Staff Report & Recommendation

Design Review Board

SUBJECT: DRB20-0507
10 West Star Island Drive

Detail of first level floor plan, south area at rear of residence.

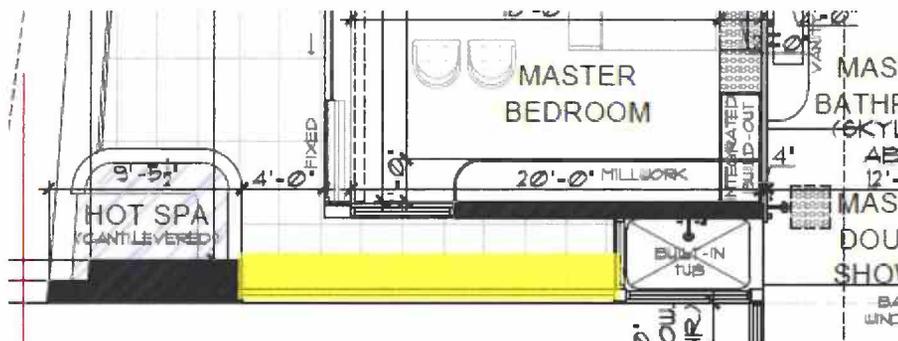
The applicant is also requesting a waiver of the open space requirement for two-story elevations that exceed 60'-0" in length along both side elevations: north and south. The house has been meticulously designed in a symmetrical configuration and contains a lot of movement along the side elevations while still maintaining the dominant sculptural quality. The design plans feature minimal side windows as it relies on the articulated skeletal-like decorative roofing and sky lighting systems that extend along the massing like a spine,

As designed, the proposed open space does not meet the Code's requirements but does effectively break up long expanses of uninterrupted two-story volumes. Staff is supportive of the side open space waiver along both sides (north and south).

Detail of second level floor plan of neighboring property (B9000417) in comparison with proposed roof plan,

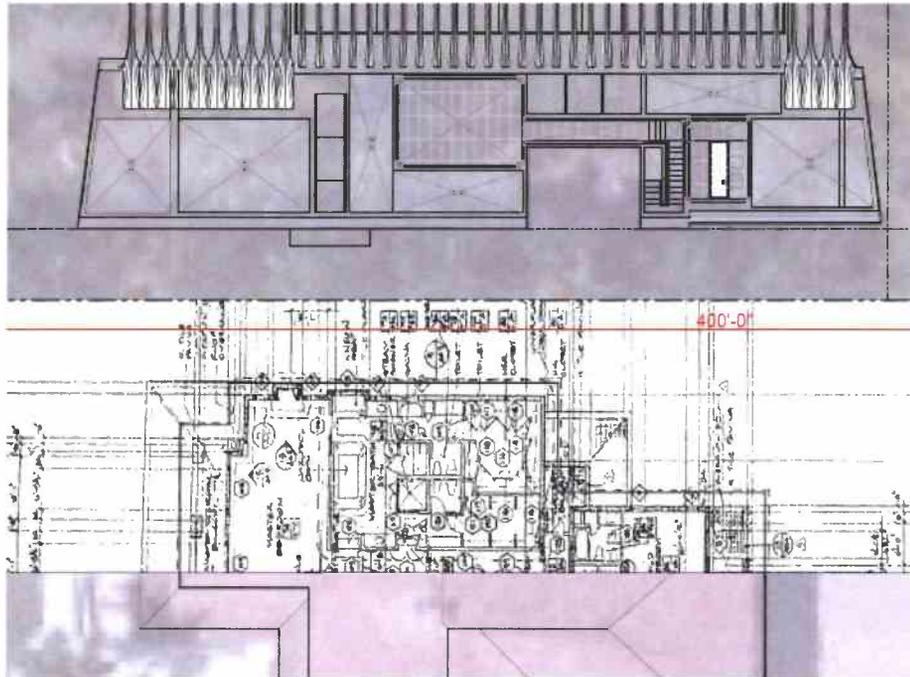
While the home's two-story side elevations exceed 60 feet in length, with a proposed length of 77'-7", there are two expansive 20'-0" wide side "notches" designed to provide some relief to adjacent neighbors from the building's massing. The quantity, size, and elevation height and quality of the open spaces provided at both sides is fully compliant with the open space requirements. Further, the notches have been configured at intervals along both elevations that break up the 43'-7" and 77'-7" volumes of the front and rear portions respectively. Should the architect have chosen to have a rigid symmetry of the house and shift the notch westerly towards the water (rear) to divide the elevations in equal halves—there would not be a need for either waiver.

Finally, when reviewing the proposed open space and the two-story elevation in relation to the neighboring property to the south, built in 1993, the approval of the waiver would not likely have a negative consequence on the neighbor. The north side second floor elevation length is 98'-4" based on the original building permit plans. Additionally, it seems there is a 30" roof overhang consistent outside of the second floor exterior walls, which brings the overall roof dimension at the north side to 103'-4" (shown at the second and roof plan). This length nearly aligns with the proposed elevation in this application.
